<b>TO</b>	Interstate Network
<b>FROM</b>	Corporate Services & Safety, General Manager Technical Standards
<b>DATE</b>	17 April 2019
<b>SUBJECT</b>	Track and Civil Code of Practice – Section 1 Rail – Technical Note ETD-01-02 for 60kg/m tangent rail profile.
<b>Amendment</b>	Minor revision to design shape (v1.1)

Figure 1. Detail of Head Profile 60 Kg/m Rail (Not to Scale)

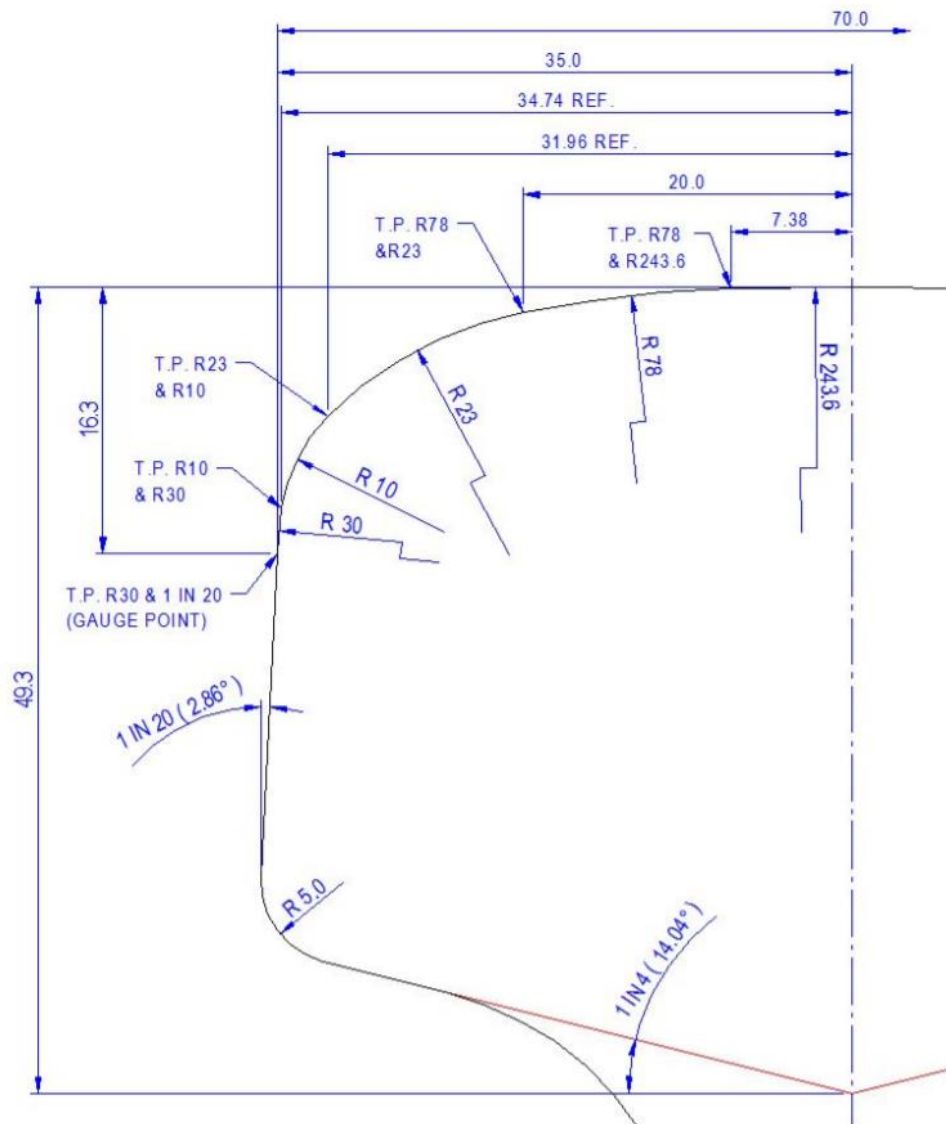
b. Track with curvature above R800m (particularly tangents) should use 60kg/m that complies with all aspects of AS 1085.1 or equivalent standard, except for the modified head profile shape as specified below in Figure 1. Marking of this modified 60kg rail profile shall comply to AS1085.1, however with the removal of the rolled in "1085.1" portion of the branding (AS to remain) and the addition of brand modification letter "T", to indicate Tangent.
